Product Change Notification

1. ECR #: 199018
Notification #: 543

2. Date of Announcement: December 23, 2020

IPBD Double Row Before and After

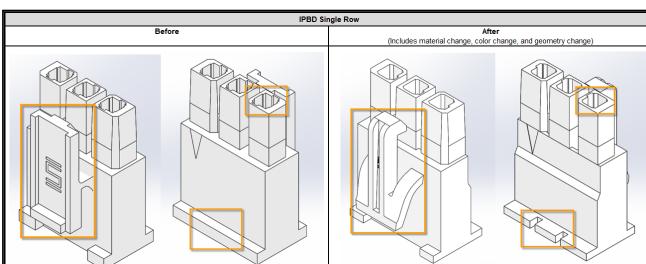
This is a change from Nylon UL 94 V2 material to Nylon UL 94 V0 material. The change improves flammability rating, while maintaining the current design of IPBD double row product, including the improved latch design that was implemented in December 2018. IPBD single row product, which includes IPBD, PMSS, and PMSST series, will also be updated to the new V0 material, as well as being updated to include body design improvements that have been in place for double row product since December 2018. The design changes for single row product include a new latch design that improves the ductility and durability of the latch, as well as a 90° rotated core and additional void coring to optimize manufacturability. The changes are backwards compatible with existing mates as well as existing crimp and poke processes. Once these changes are implemented, older versions of IPBD product that use "REF" part numbers will be phased out. However, the phase out dates for these products will be determined at a later date pending existing PO's and last-time buy agreements. Customers moving from a "REF" part number to a standard IPBD double row part number can expect to see the same visual, material, and geometry changes that are being applied to IPBD single row product. See "IPBD Single Row Before and After" and "IPBD Double Row Before and After" images for reference.

8. Impact of Change on Form, Fit, or Function: <ul style="list-style-type: none"> Form - For IPBD single row product only, there will be a change in latch geometry, increased void coring, and 90° rotated cores. Form - For both single row and double row product, the new bodies will have a white appearance, which is different than existing bodies which have an off-white/cream appearance. Fit - There is no change to the fit of IPBD product. All changes are compatible with existing mates, as well as crimp and poke assembly. Function - The change from V2 to V0 nylon improves flammability resistance.
